Scope of the revision

29th Floor - M-529 SD R2: Bubbled Areas

30th Floor - M-530 SD R2: Scope and Quantities

31st Floor - M-531 SD R2: Scope and Quantities

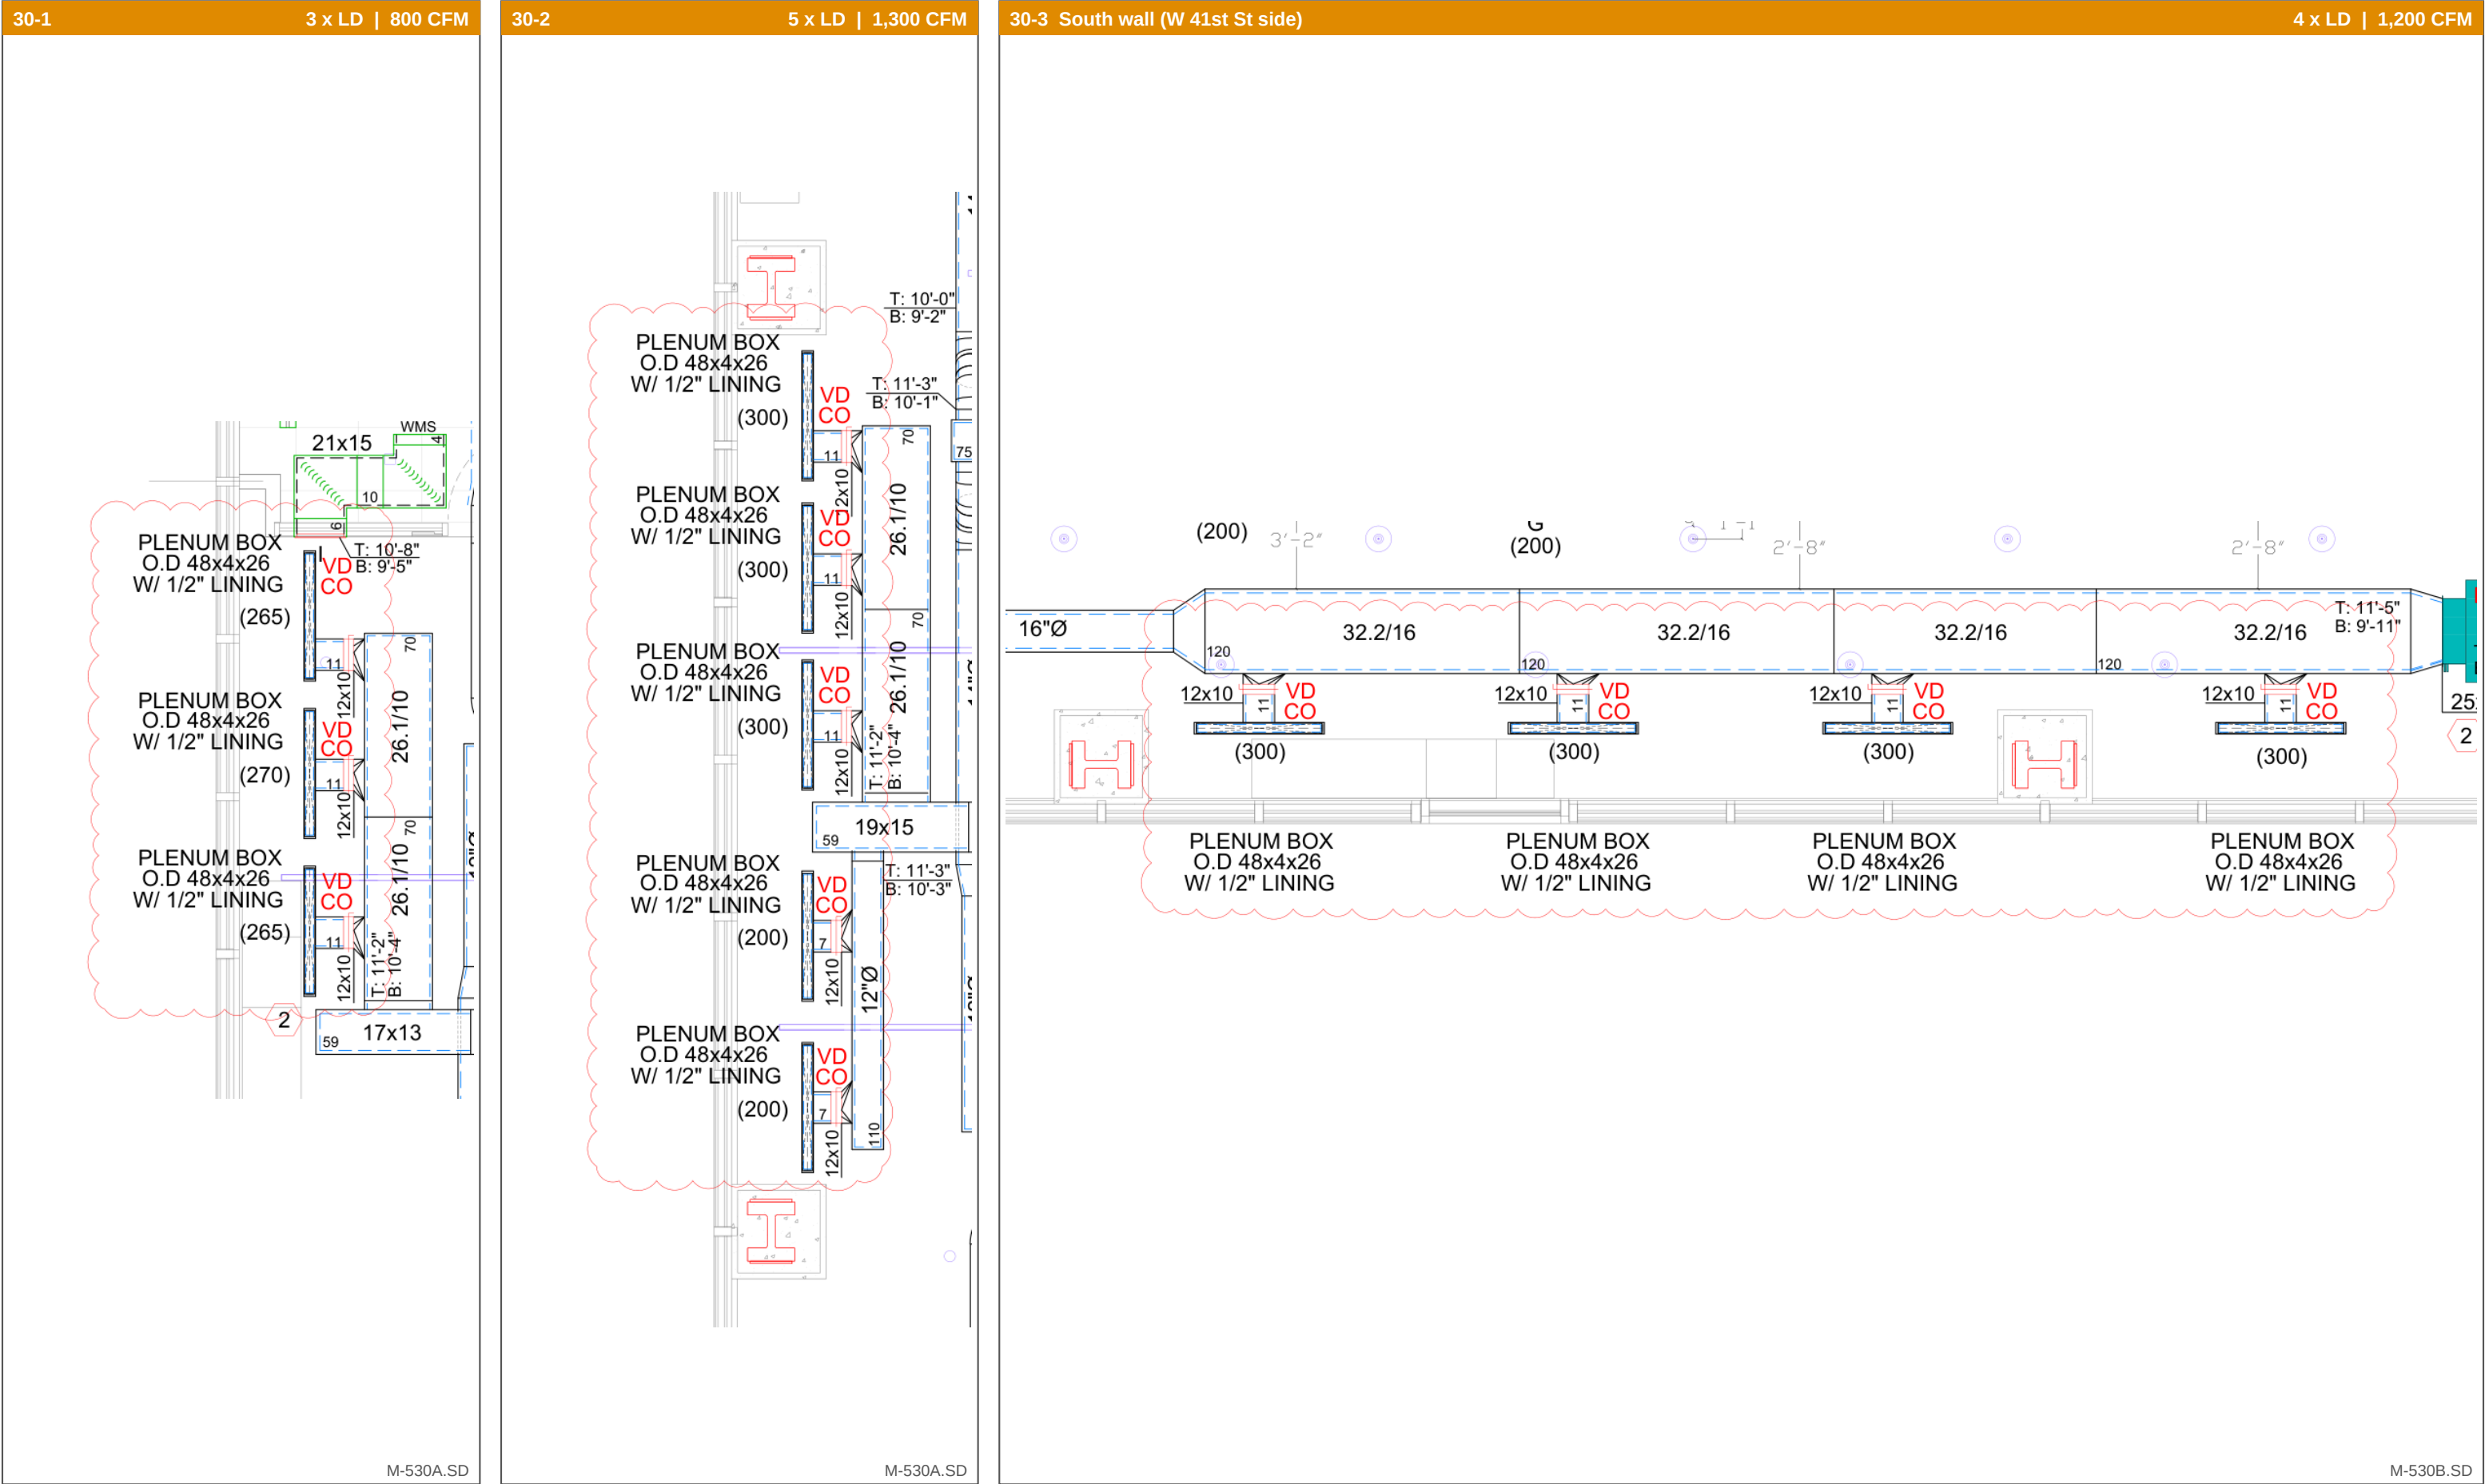
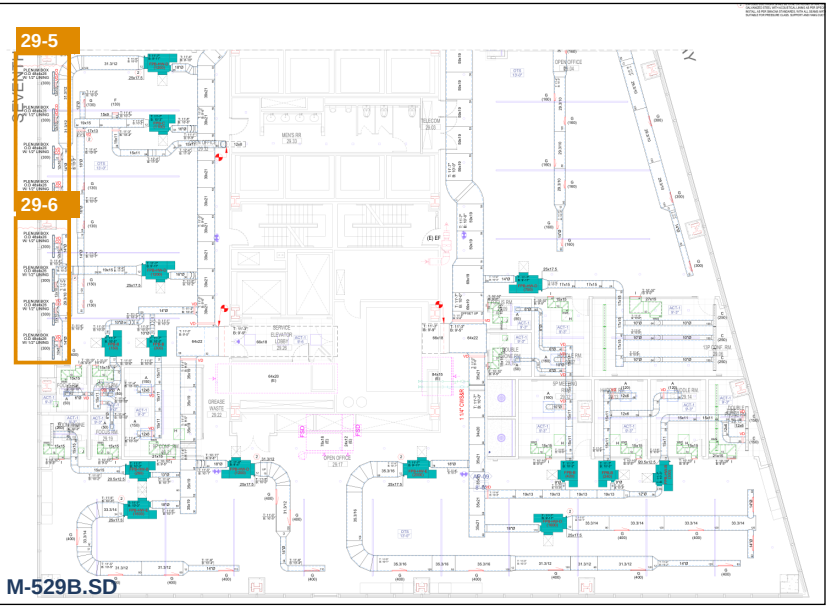
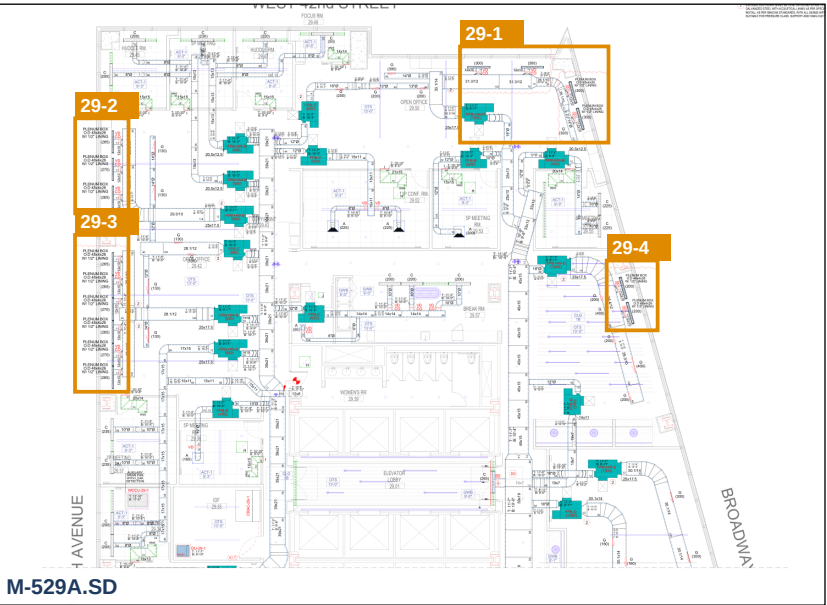
23 perimeter linear diffusers in plenum boxes O.D. 48x4x26 w/ 1/2" lining, 6,400 CFM | quantities on next page

Area	Location / scope	LD qty	CFM each (total)	Branches	VD/CO tagged	Perimeter main in bubbled area (reference only)
29-1	North-east corner, W 42nd St / Broadway F&I 4 perimeter linear diffusers with plenum boxes; 4 branch taps off main with VD/CO, insulation, soffit coordination. 2 diffusers along 42nd St off the 31.3/12 main, 2 along Broadway off the 26.1/10 / 14"Ø run.	4	300 / 300 / 300 / 300 (1,200)	4 x 12x10, 25 in total	4	31.3/12 approx. 16 LF; 26.1/10 with offset down approx. 6 LF; 14"Ø approx. 6 LF
29-2	Seventh Ave, north F&I 3 perimeter linear diffusers with plenum boxes; 3 branch taps off main with VD/CO, insulation, soffit coordination.	3	265 / 270 / 265 (800)	3 x 12x10, 33 in total	3	29.3/10 approx. 13 LF
29-3	Seventh Ave, Open Office 29.42 F&I 6 perimeter linear diffusers with plenum boxes; 6 branch taps off main with VD/CO, insulation, soffit coordination. VD/CO tagged on 2 of 6 connections.	6	265 / 265 / 270 / 265 / 270 / 265 (1,600)	6 x 12x10, 66 in total	2	26.1/10 approx. 20 LF (with tee)

29-4	Broadway, north F&I 2 perimeter linear diffusers with plenum boxes; 2 branch taps off main with VD/CO, insulation, soffit coordination.	2	200 / 200 (400)	2 x 12x10, 14 in total	2	34.4/12 approx. 8 LF
29-5	Seventh Ave, south (north end of sheet B) F&I 4 perimeter linear diffusers with plenum boxes; 4 branch taps off main with VD/CO, insulation, soffit coordination.	4	300 / 300 / 300 / 300 (1,200)	4 x 12x10, 40 in total	4	31.3/12 approx. 12 LF; 14"Ø approx. 8 LF
29-6	Seventh Ave, south F&I 4 perimeter linear diffusers with plenum boxes; 4 branch taps off main with VD/CO, insulation, soffit coordination. Last connection 10x8. VD/CO tagged on 3 of 4.	4	300 / 300 / 300 / 300 (1,200)	3 x 12x10, 30 in total 1 x 10x8, 10 in total	3	14"Ø approx. 13 LF; 29.3/10 approx. 7 LF
	29th floor total	23	6,400	22 x 12x10 1 x 10x8	18

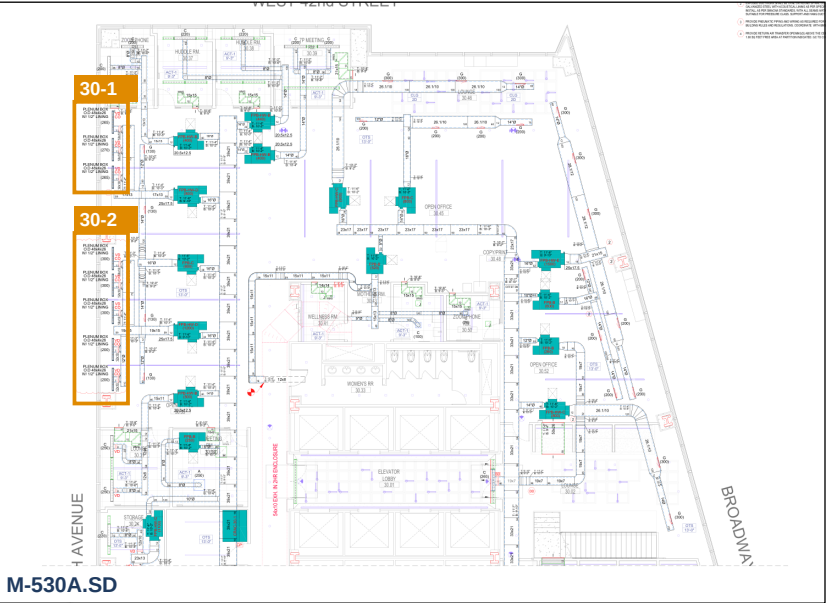
Area	Location / scope	LD qty	CFM each (total)	Branches	VD/CO tagged	Perimeter main in bubbled area (reference only)
30-1	Seventh Ave, north F&I 3 perimeter linear diffusers with plenum boxes; 3 branch taps off main with VD/CO, insulation, soffit coordination.	3	265 / 270 / 265 (800)	3 x 12x10, 33 in total	3	26.1/10 approx. 12 LF
30-2	Seventh Ave, Open Office 30.35 F&I 5 perimeter linear diffusers with plenum boxes; 5 branch taps off main with VD/CO, insulation, soffit coordination. 3 off the 26.1/10, 2 off the 12"Ø below the 19x15.	5	300 / 300 / 300 / 200 / 200 (1,300)	5 x 12x10, 47 in total	5	26.1/10 approx. 12 LF; 12"Ø approx. 9 LF
30-3	South wall (W 41st St side) F&I 4 perimeter linear diffusers with plenum boxes; 4 branch taps off main with VD/CO, insulation, soffit coordination.	4	300 / 300 / 300 / 300 (1,200)	4 x 12x10, 44 in total	4	32.2/16 approx. 40 LF
	30th floor total	12	3,300	12 x 12x10	12

31-1 Seventh Ave, north (Focus Rm 31.65 / Corridor 31.51)

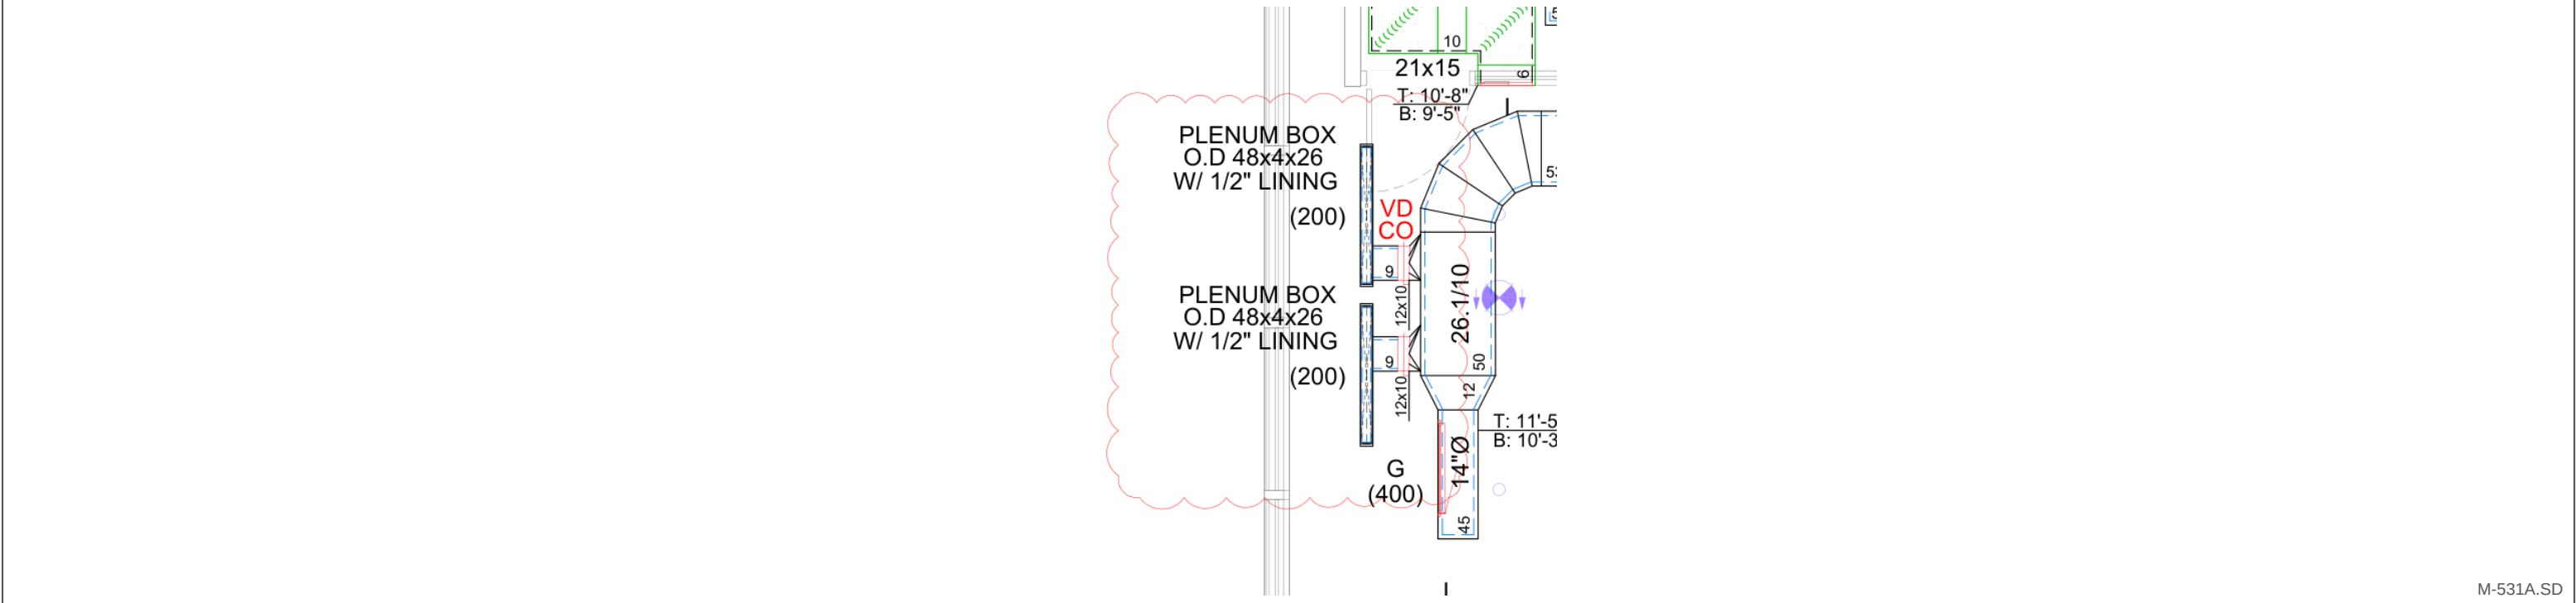
2 x LD | 400 CFM

31-2

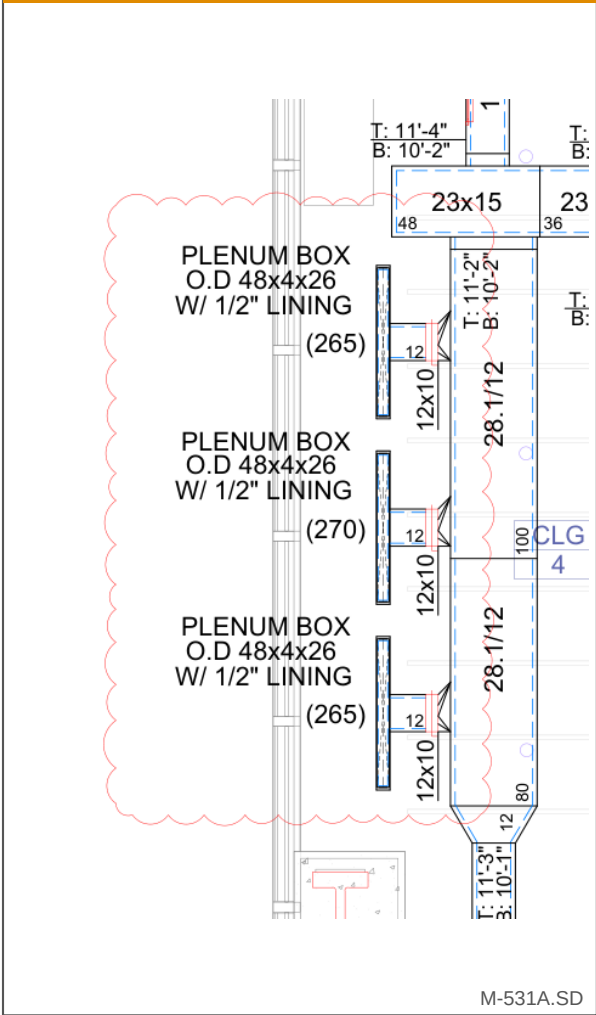
3 x LD | 800 CFM

31-3

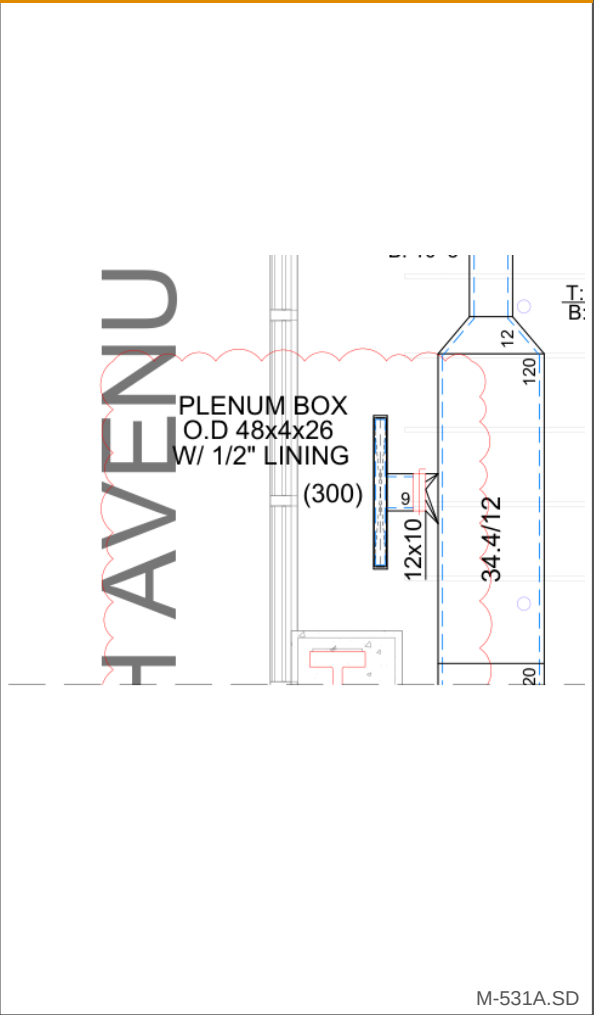
1 x LD | 300 CFM

31-4

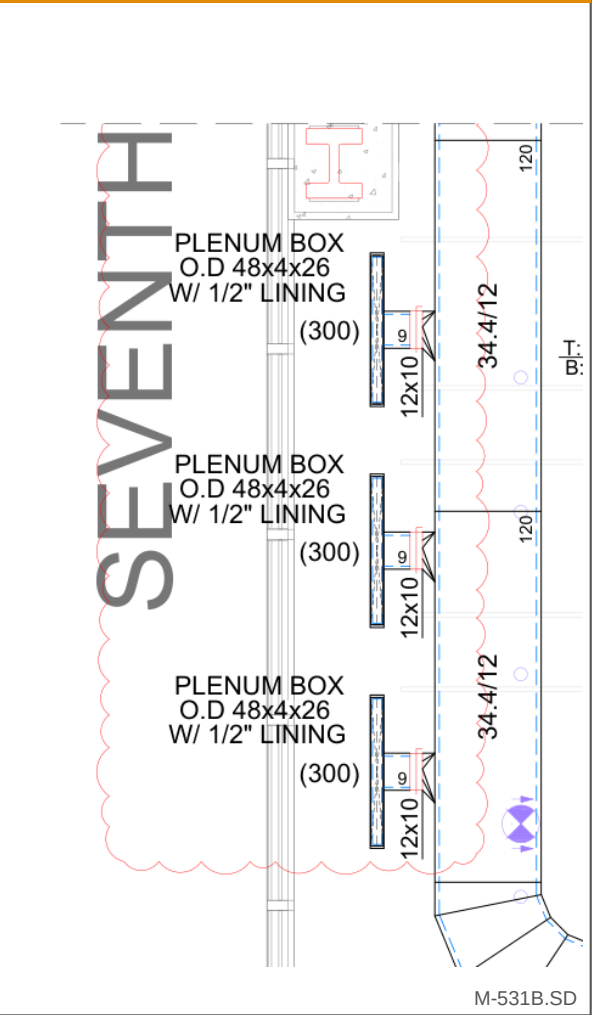
3 x LD | 900 CFM

31-5

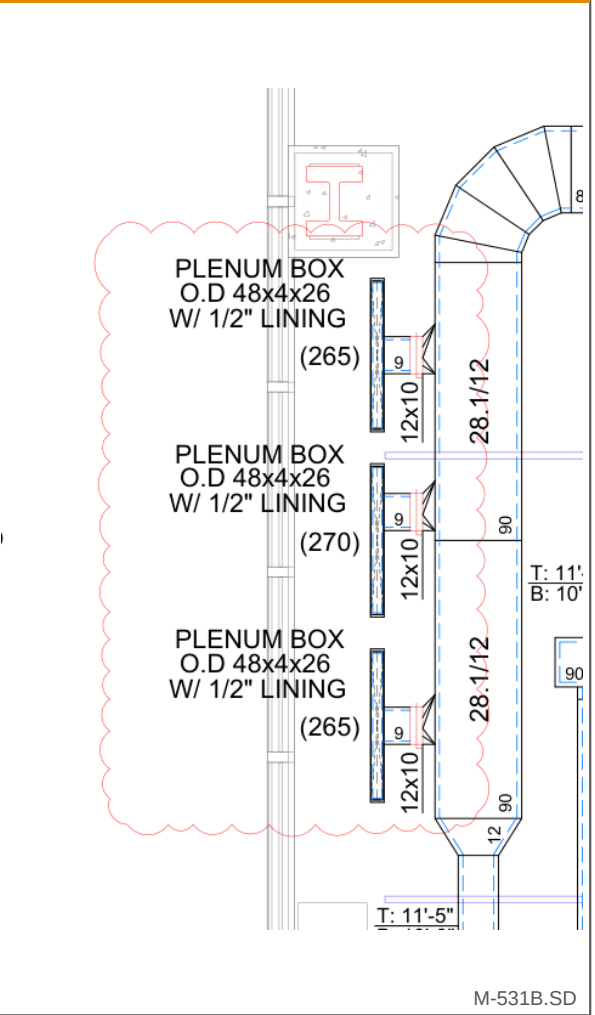
3 x LD | 800 CFM

31-6

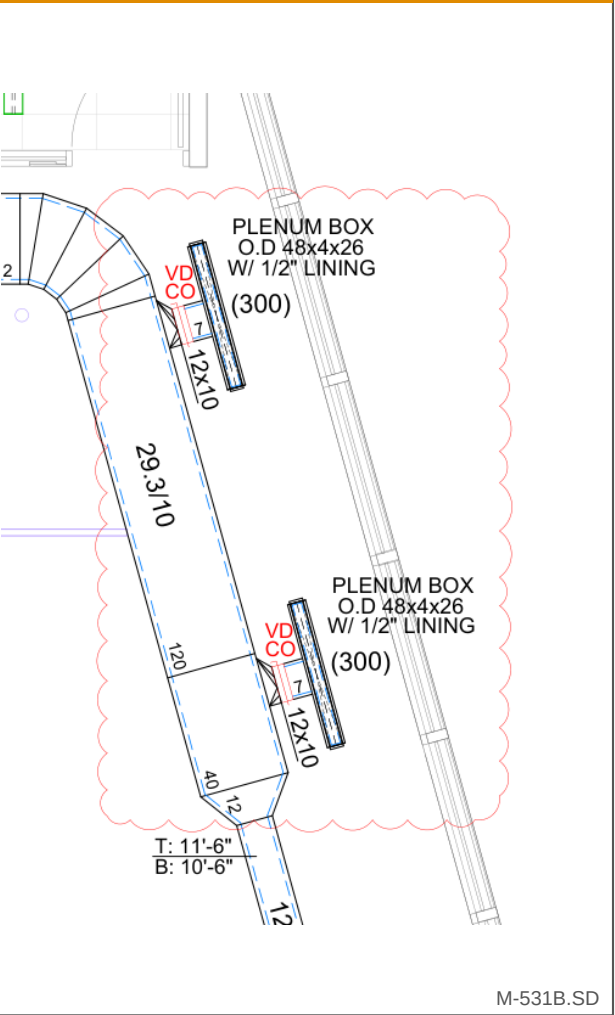
2 x LD | 600 CFM
